GENERAL ELECTRIC TEST REACTOR
RESPONSE TO
ADDITIONAL INFORMATION REQUEST
REGARDING SEISMIC SCRAM SYSTEM

Prepared for
General Electric Company
Pleasanton, California
15 September 1980

FIGURE 1 ENVELOPE OF MAXIMUM HORIZONTAL ACCELERATIONS
AFTER RECORDING 0.01g

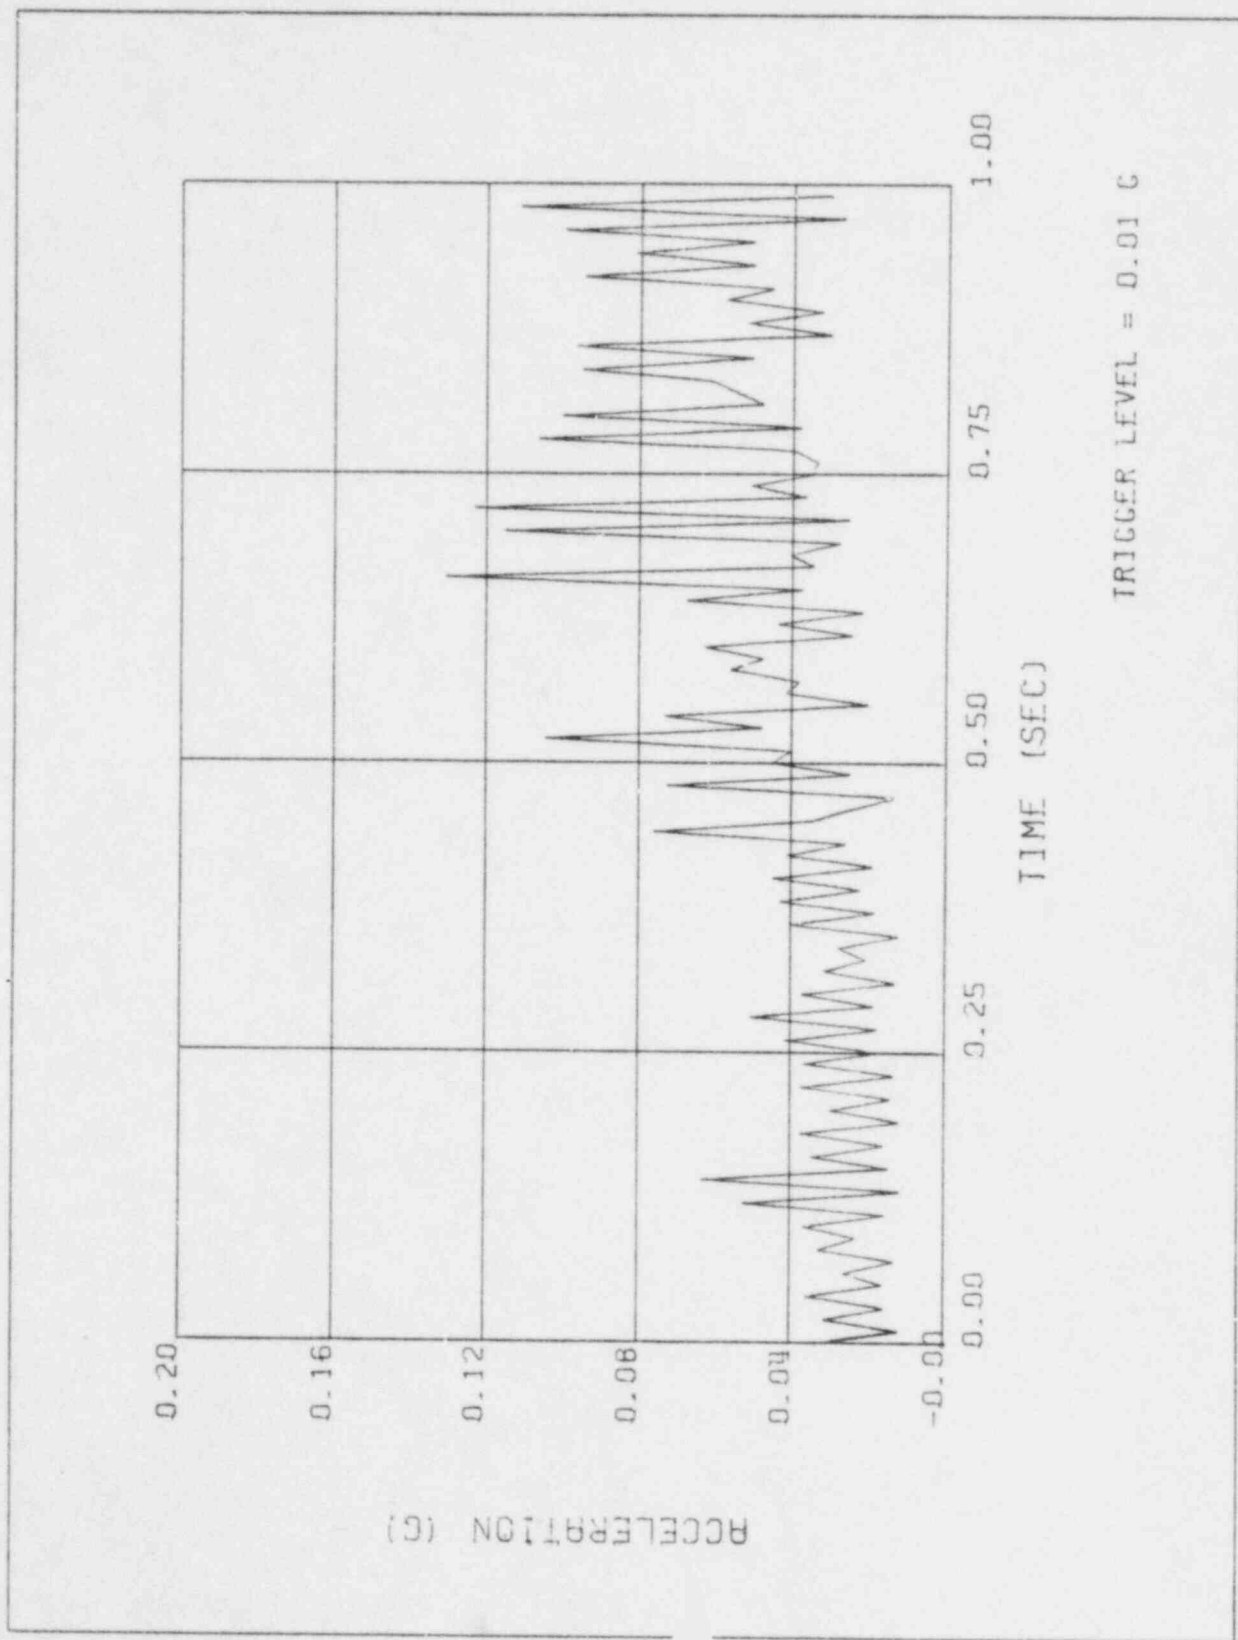
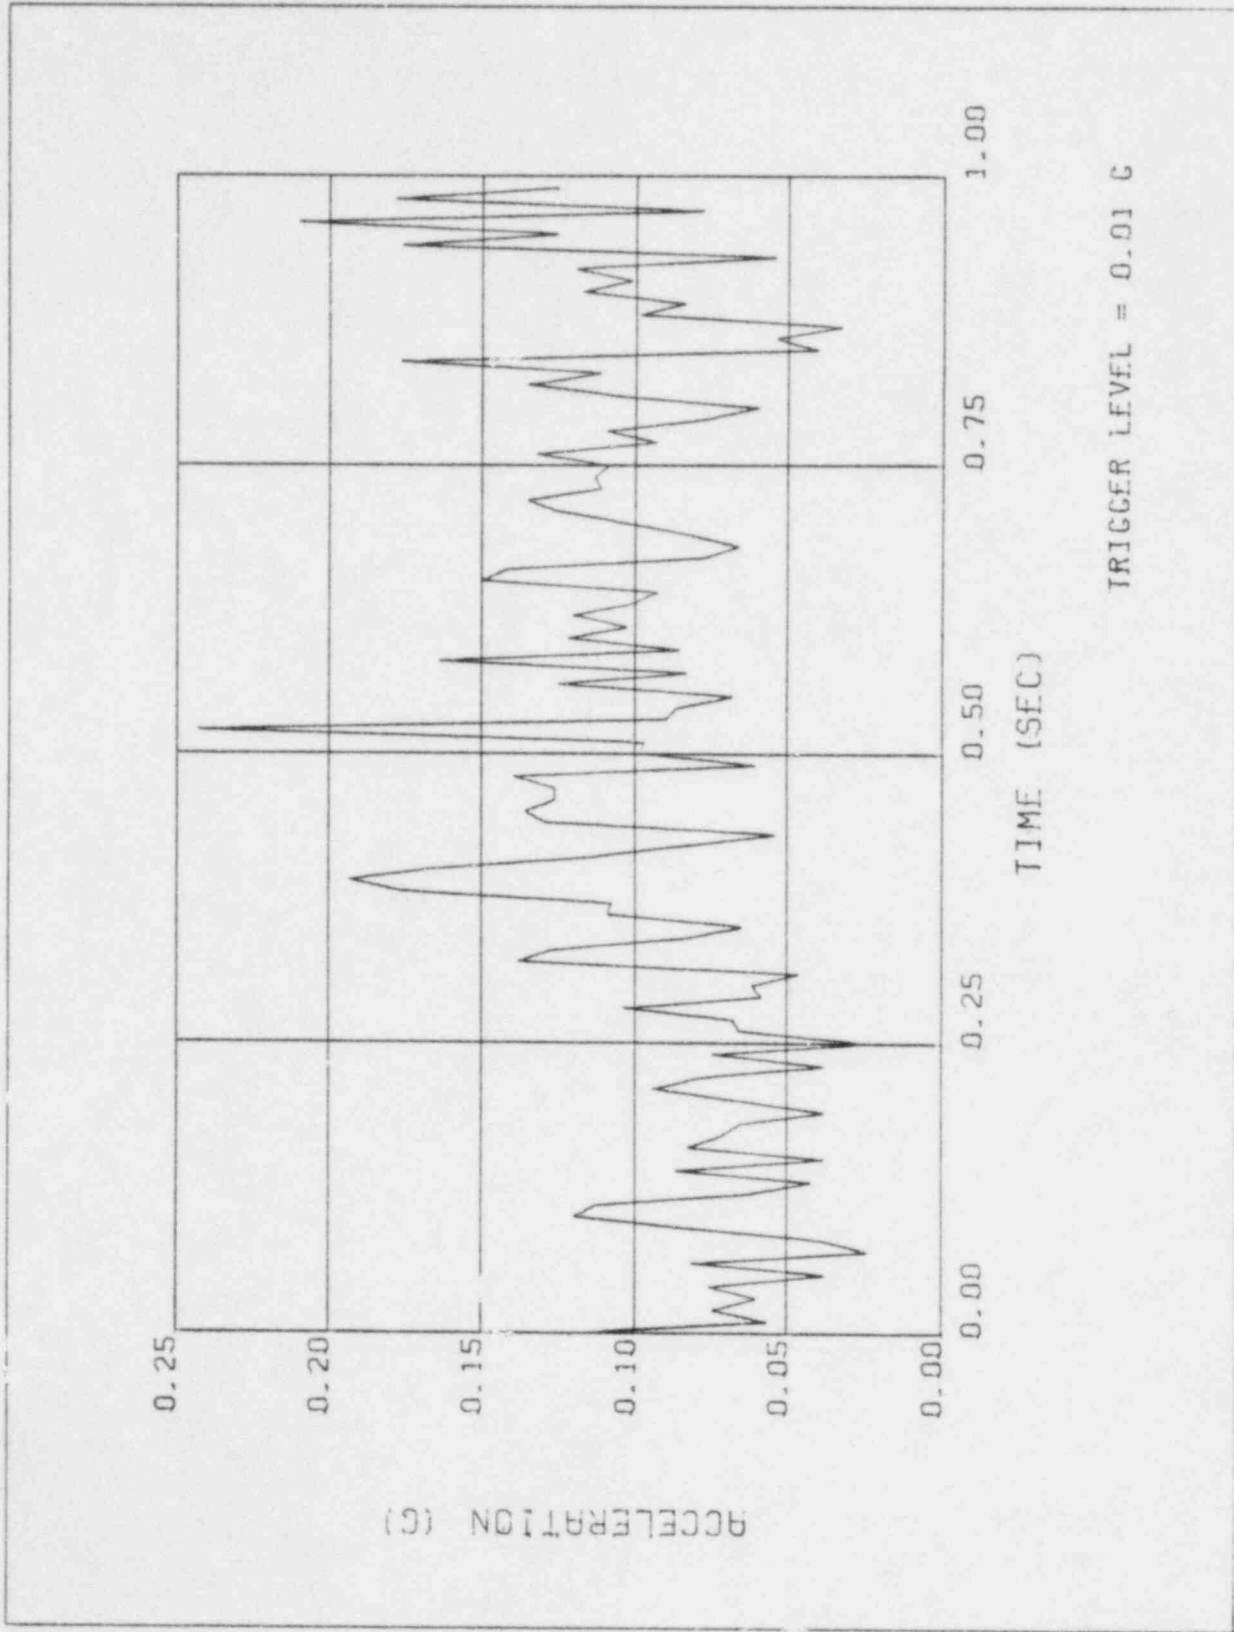
"Describe the source of the computerized earthquake records used to determine the maximum instrumental accelerations in Table 1 and provide data plots of the time histories illustrating acceleration levels from seismic scram actuation through the time to complete control rod and valve operation."

Figures 1 and 2 provide envelopes of the absolute values of acceleration time histories as explained in the Preface.
